Submission on the Environmental Impact Statement for Newcastle Inner City Bypass Rankin Park to Jesmond Section Project.

From Grant and Jill Fraser: Residents and Business Owners of 'Home Occupation' Business, teaching and recording music studio that is 'Permitted without consent' in Zone R2 under Newcastle Local Environment Plan 2012.

Figure 4. The northern verge of Grandview Road looking east towards Lookout Road intersection.

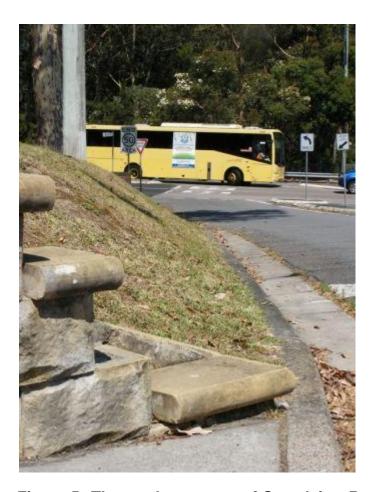
There is no continuous footpath from the northern corner of Grandview and Lookout Road. Pedestrians who wish to walk in a westerly direction along Grandview Road from this corner have to physically walk on the road. They have to do this into oncoming traffic that has limited vision due to the crest of the hill. (Please also see pages 28 to 36 of this submission)

Figures 4 and 5 below show the masonry wall at the bus stop that is impossible to pass without walking on the road.
